FERN STREET, N.W.

New construction

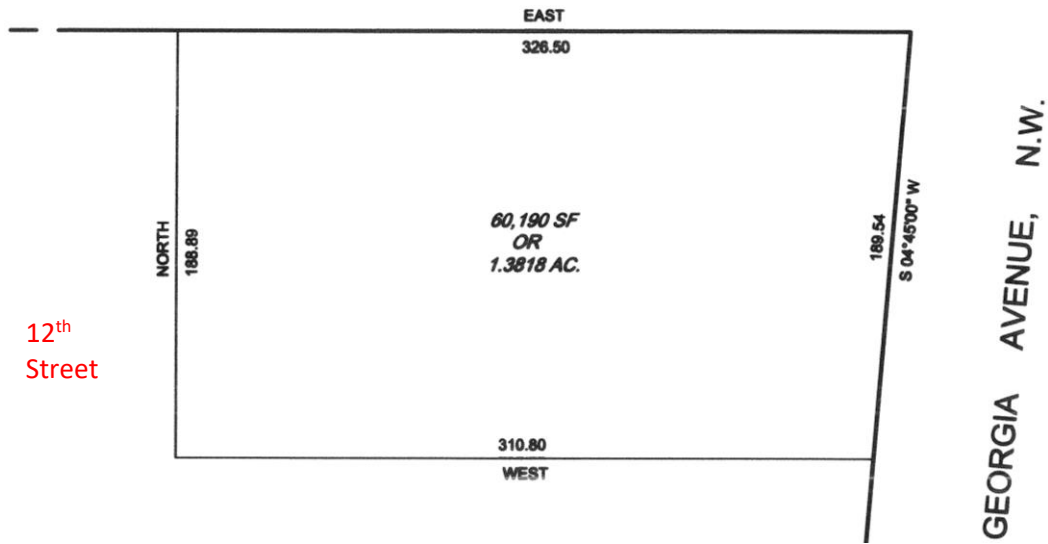
A first observation on the application is that the site plan feels congested, numbering nearly 30 more buildings than the previous plans for “Fern Park”—characterized as a low-density neighborhood in master plan—which is more than could have been accommodated simply by replacing the formerly anticipated commercial building with townhouses. Although these earlier plans were illustrative, they did create some expectations about what would be built, because there were more than schematic drawings.

The small-area plan proposed H-plan alleys of 20 feet wide and 20-foot rear yards, with the houses fronting the streets and mostly backing up to the longer east-west alleys, each stick of townhouses largely screening the rear of another, similar to the approach of the recent townhouse project at the south end of campus. The plan’s text provided the following guidance:

The small-area plan notwithstanding, the master plan illustration had effectively done away with rear yards except as approaches to garages (the zoning regulations require no rear yards). But the front yards had been retained.

The additional density of the present site plan harms the site plan in two respects. First, the depths of the front yards are reduced on Fern Street and within the development. The small-area plan called for "Explor[ing] minimum 20 feet pedestrian zones distance from building face to curb for landscaped front yards, pedestrian circulation and curbside rain gardens and trees...."

and illustrated that full 20 feet in front of porches. In this application, the distance is 14.7 feet from curb to the Fern Street porches, leaving a 5.3-foot planting strip inside the public sidewalk. (The porches themselves are said to project six feet, but look shallower in some of the sections. A proper porch depth is an important detail, both for its function and its proportionality to the house behind.)

Second, many of the units have been turned perpendicular to Elder Street, addressing that right-of-way with a narrow green strip and, beyond, exposing to view the internal paving and the rears of the buildings, with their garages, siding, and penthouses. There are some screen walls or fences suggested (see pages 34 and 35), but in those locations on the planting strips in the right-of-way, they would have to be no taller than 42 inches and mostly open. The informal sides of the four-story townhouses would face Elder; the southern porticoes of the stacked units are right at the Elder Street sidewalk. Front and back, the windows are said to be Andersen 100 Series single-hungs of Fibrex composite (i.e., plastic and wood fiber), a product that is typically not approved on the fronts of buildings in historic districts because of its joinery and the fact that it may, but not necessarily will, have external muntins or “grilles.” (The doors are to be fiberglass, which is acceptable if smooth and painted.)

HPO recommends that the Board recommend clearance of the subdivision and request revisions to the concept for new construction along the lines suggested above, including refining the fourth stories, the fenestration, the details, the window products, and the spacing of bays and piers, especially at the Georgia Avenue buildings. It is further recommended that the applicant consider a site plan that is somewhat less congested, with more buildings fronting Elder Street and deeper front yards.
